## STAFF COMMENTS

### ADDENDUM TO PREVIOUS STAFF COMMENTS PROVIDED DECEMBER 14, 2016

**Case #37-16: SITE PLAN APPROVAL  
MODIFICATION**  
50 Duchaine Boulevard  
Map: 134, Lots: 456, 457, 458 & 459

The submittal is shown as the Site Plan for 50 Duchaine Blvd (Assessors Map 134, Lots 456, 457, 458 and 459) New Bedford, MA dated November 18, 2016 prepared for Eversource Energy, P.O. Box 100085-N2, Duluth, GA 30096 by Thompson Farland 398 County Street, New Bedford, MA 02740, consisting of nine (9) sheets; and

NOVEMBER 18, 2016  
SCALE: AS NOTED  
JOB NO. 15-500  
LATEST REVISION:  
COVER SHEET  
SHEET 1 OF 9

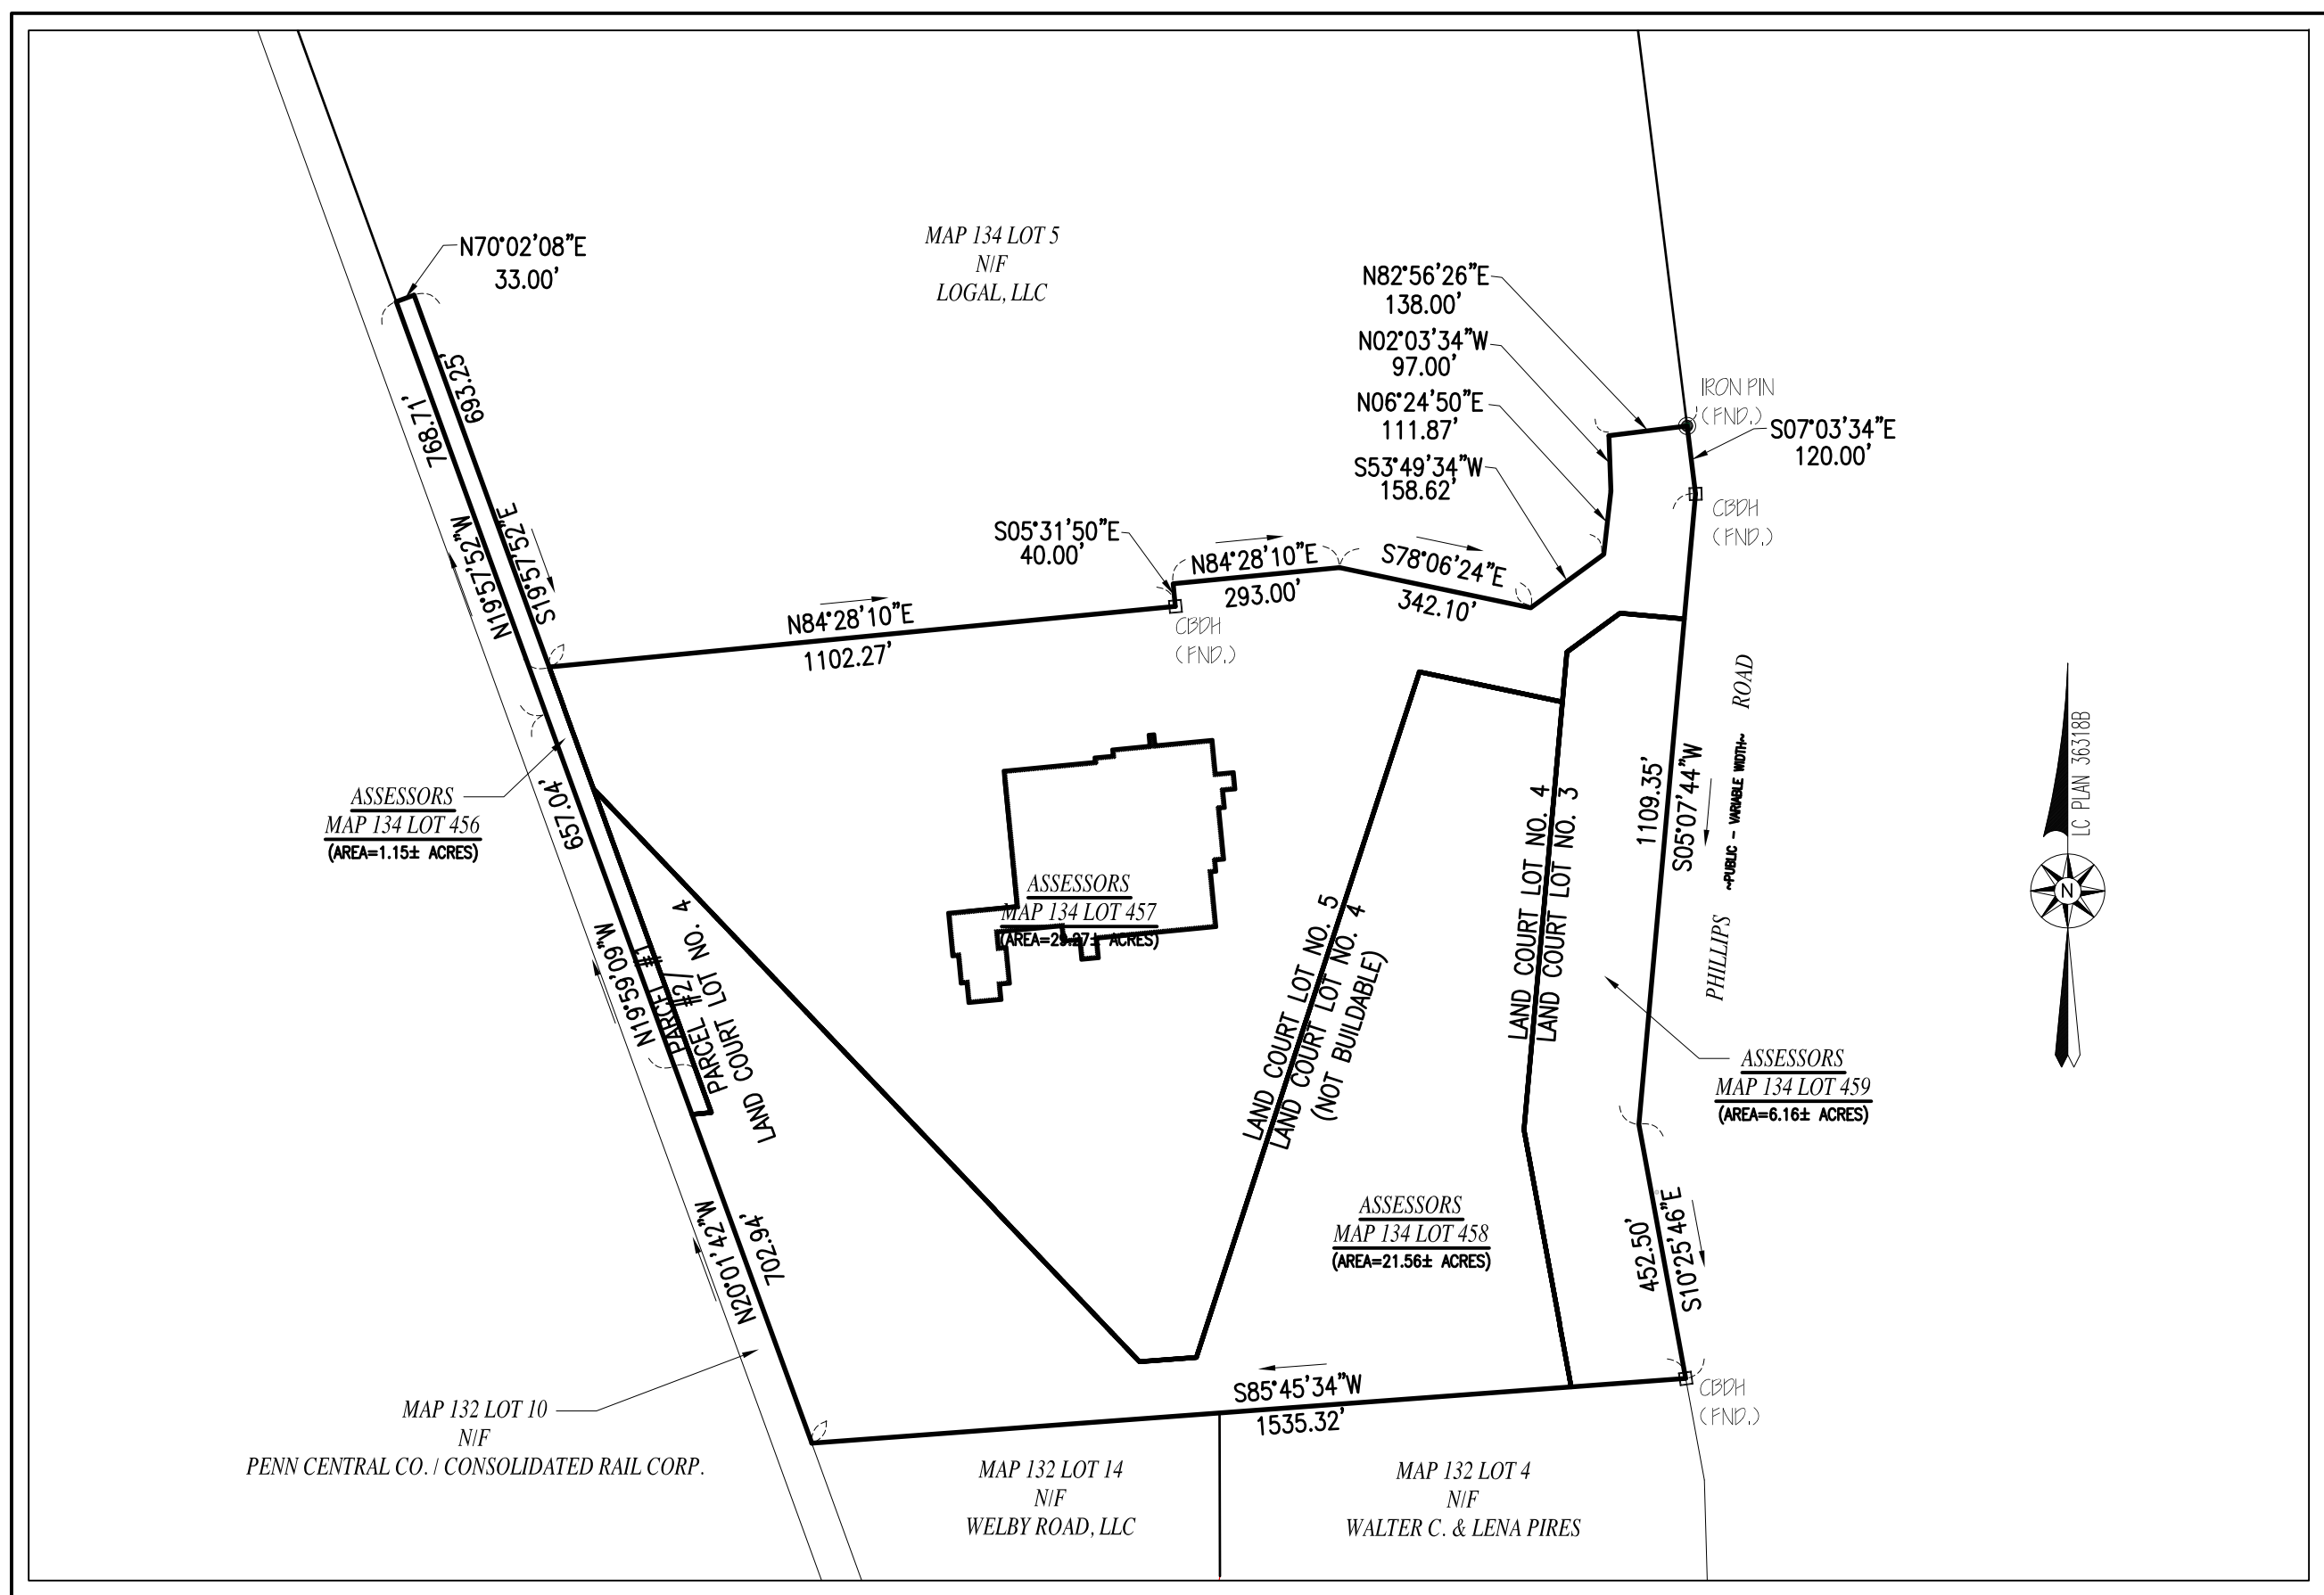
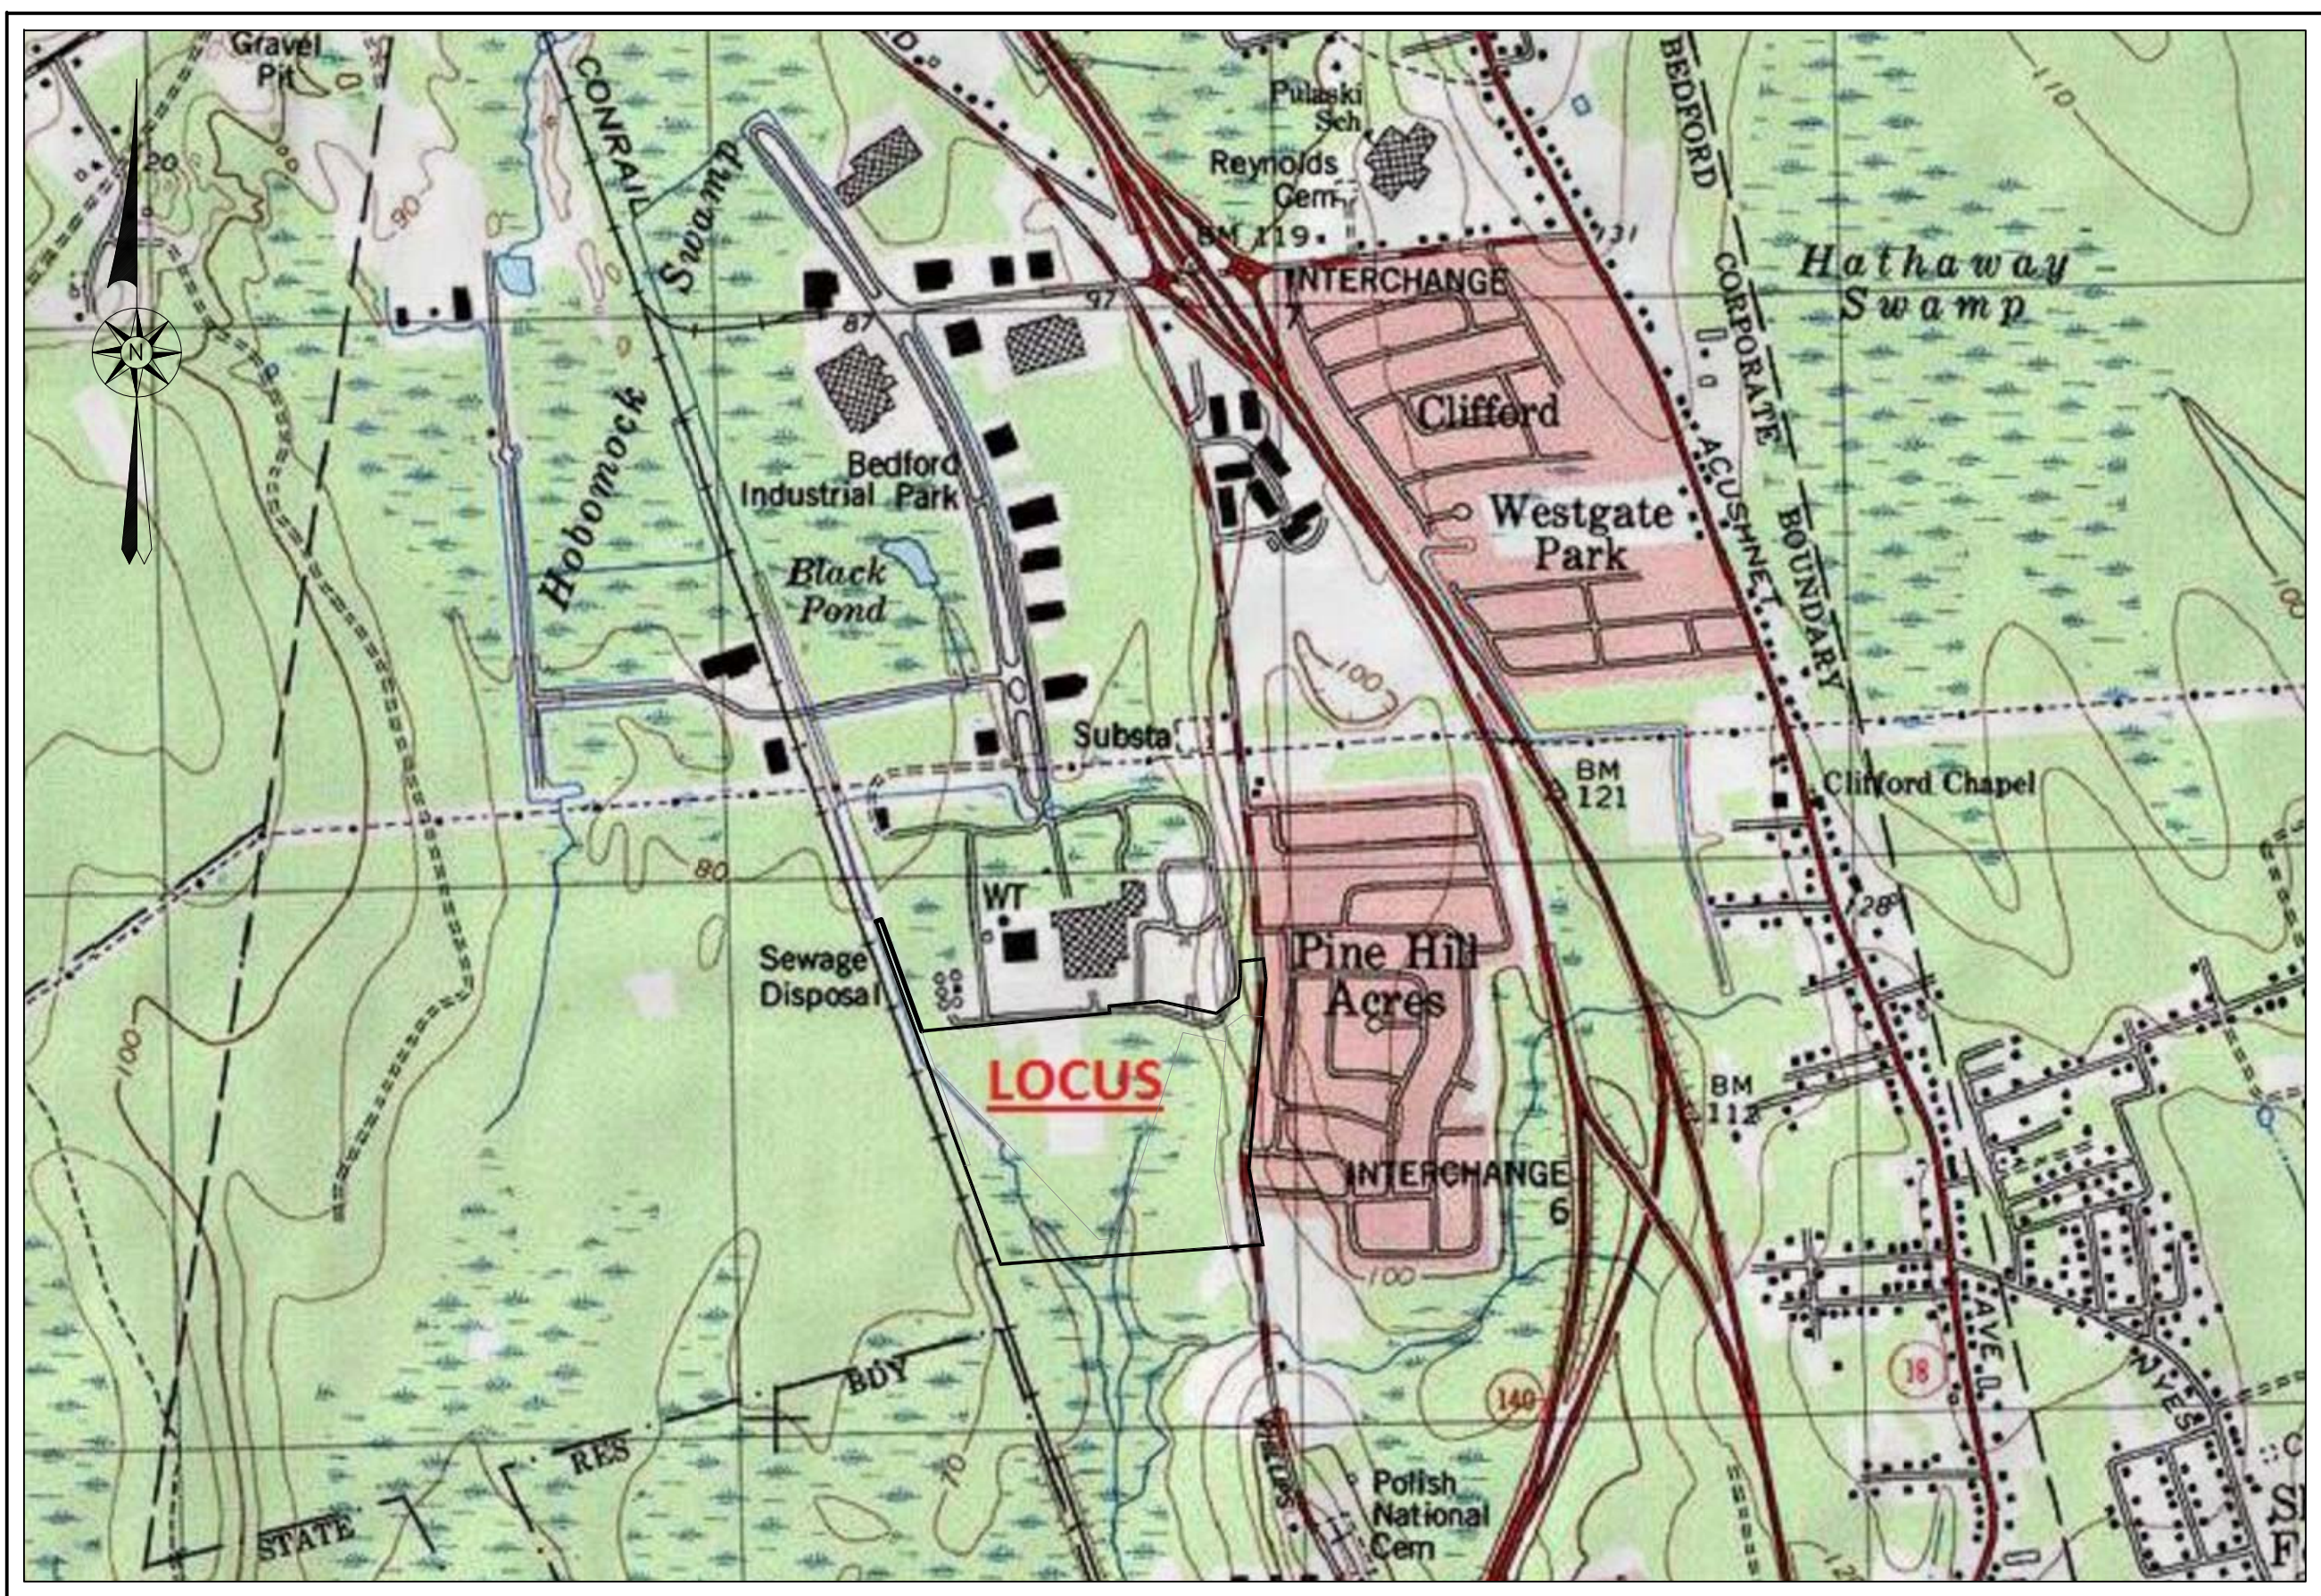
- **Cover Sheet - Sheet 1 of 9**
  - Revise the number of parking spaces provided using City ordinance regulations of nine (9) feet by twenty (20) feet.
- **Notes & Legend - Sheet 2 of 9**
  - Under General Construction Notes at No. 19, add “and City Planner”.
  - Under General Planting Notes, add **Period of planting:** March 15-May 15 and September 15-November 15, weather permitting.
- **Existing Conditions - Sheet 3 of 9**
